**Jordan Cove Energy Project L.P.**

**Resource Report No. 6**

**Jordan Cove Energy Project**

## Responses to FERC's August 11<sup>th</sup> Comment List

Figure 6.4-3: Landslide Susceptibility in the Vicinity of the LNG Terminal Site

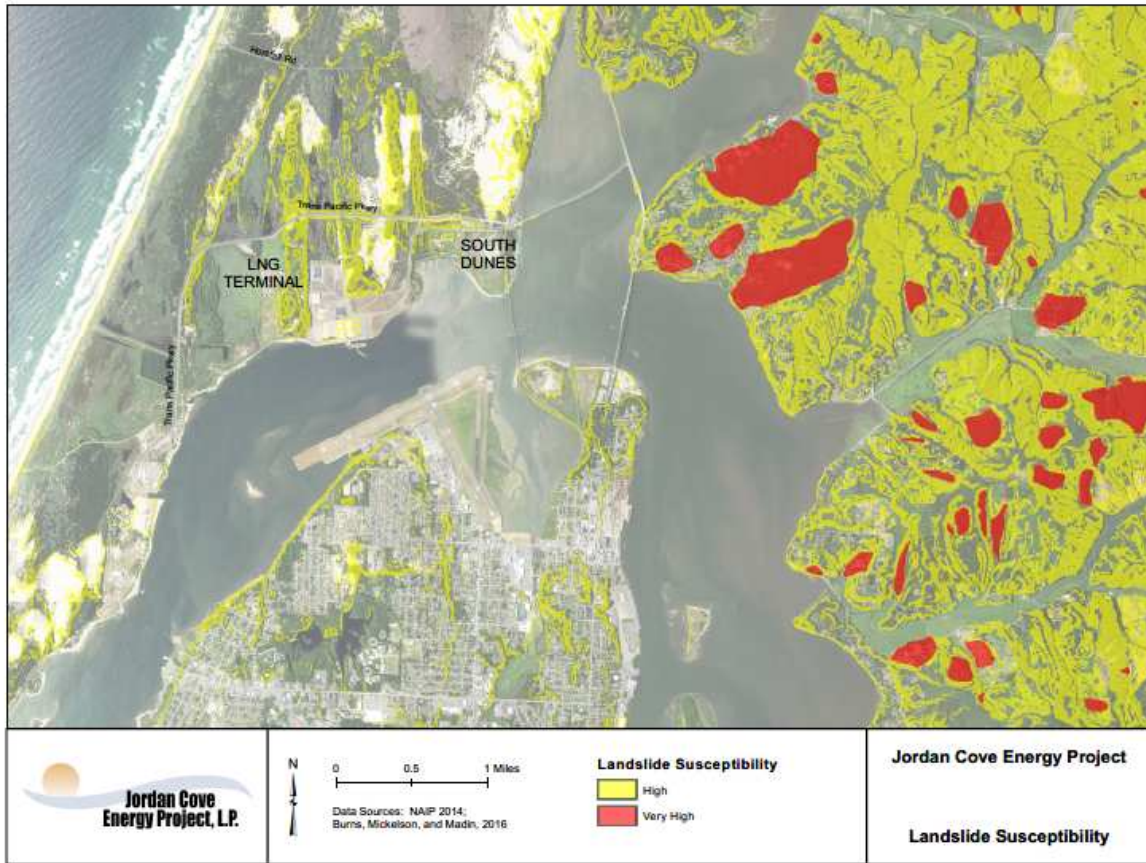
Agency	Agency Comment #	Agency Comment	Response Summary
NMFS	6.1	The report indicates that there is a high susceptibility for landslides on slopes surrounding Kentuck Slough. A description of that risk to the mitigation site and any waterbodies potentially affected needs to be included as part of the BA.	See RR6 for landslide risk description..
NMFS	6.2	Design of the rip rap slopes and vegetation system for the Marine Basin and the MOF should be included in the BA.	Will be included in BA
FERC	1	Include supporting literature to justify the statement regarding the time period of "low historical seismicity".	Added reference to RR6 - 6.4.1.1 - Earthquakes.
FERC	2	Include a discussion and supporting literature regarding the historical evidence of earthquake activity related to the Cascadia Subduction Zone (CSZ), and for the several earthquakes that took place in 1873 within 75 miles of Coos Bay.	Added narrative to RR6 - 6.4.1.1 - Earthquakes.
